# 1.6TbE PCS FEC Codeword Examples and Vector Files for Clause 175 and Annex 175A, in support of D1.0 comments #453 and #455

IEEE P802.3dj

May Interim 2024

Figure 175-7—1.6TBASE-R PCS transmit data distribution and bit ordering

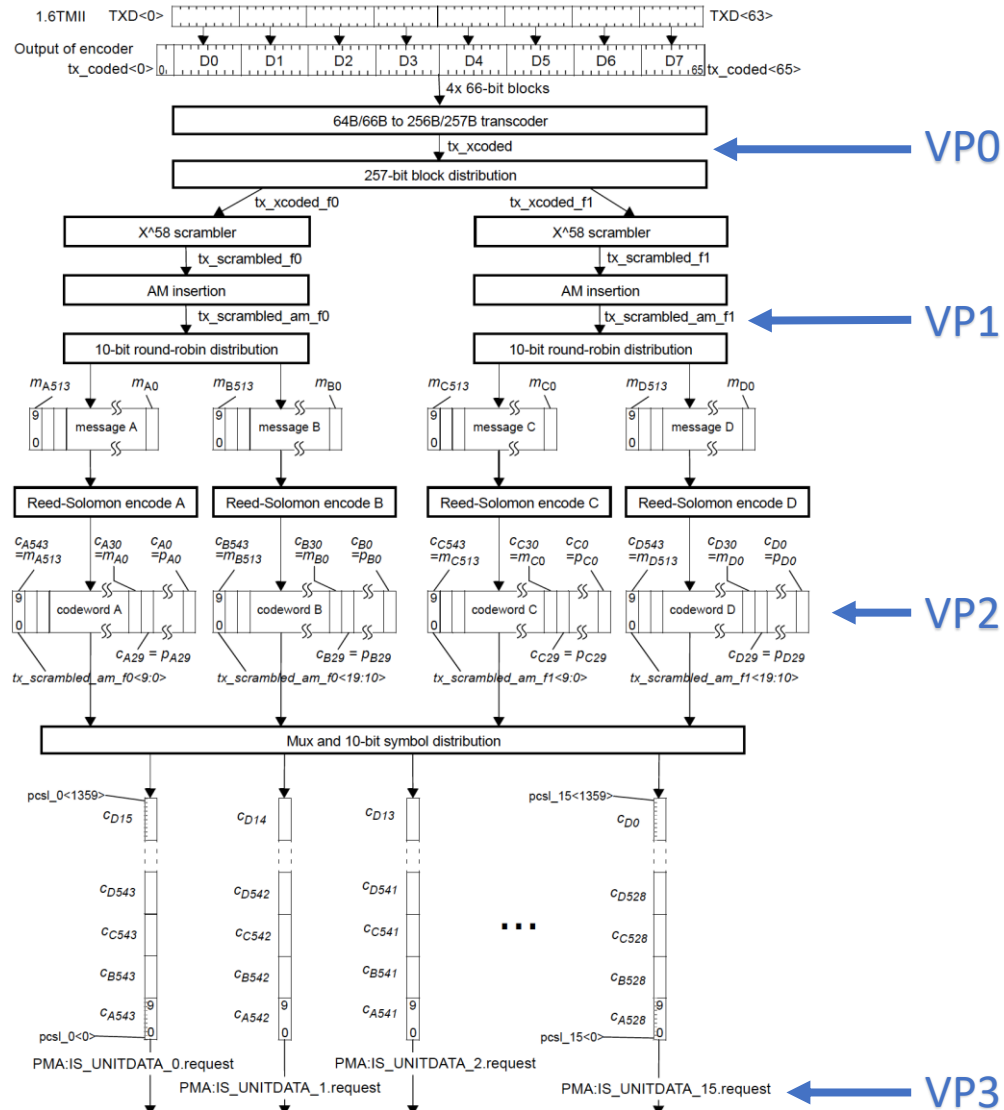
• Vector test points (VP<sub>x</sub>) in the 1.6TbE PCS example in Annex 175A:

- VP0: tx\_xcoded
- VP1: tx\_scrambled\_am\_f0 and tx\_scrambled\_am\_f1
- VP2: RS-FEC codewords A, B, C, D
- VP3: PCSL\_[0..15]
